Restraint Equipment

AD/RES/19

Am-Safe Harness Buckle Assemblies

4/87

LOT NO .

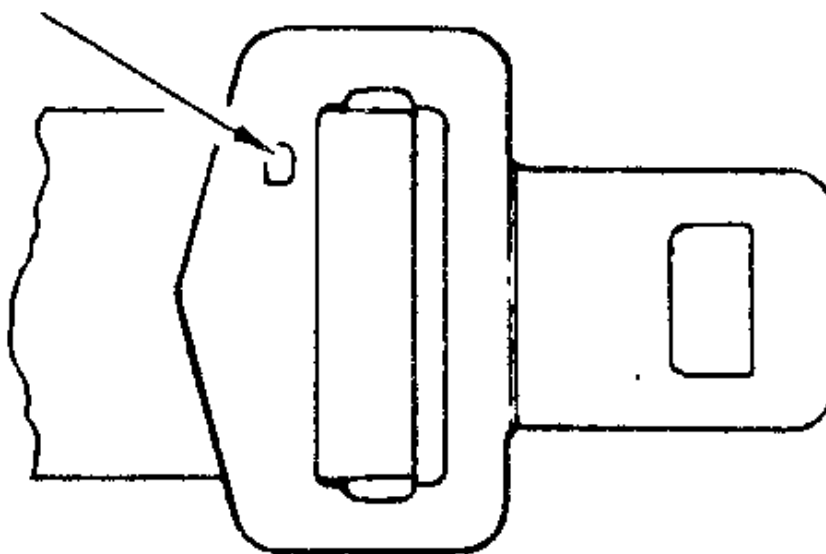
Requirement: Inspect the male portion/s of the buckle assembly. Remove from service any connector identified as Lot 04. Am-Safe Mandatory SB AS 001 refers.

Background: There is a possibility that items from the subject batch may dislodge from the buckle if a side load is applied to the assembly.

Compliance: Prior to the issue of the next Maintenance Release after 9 April 1987 or within 100 hours time in service after 9 April 1987 whichever is later.
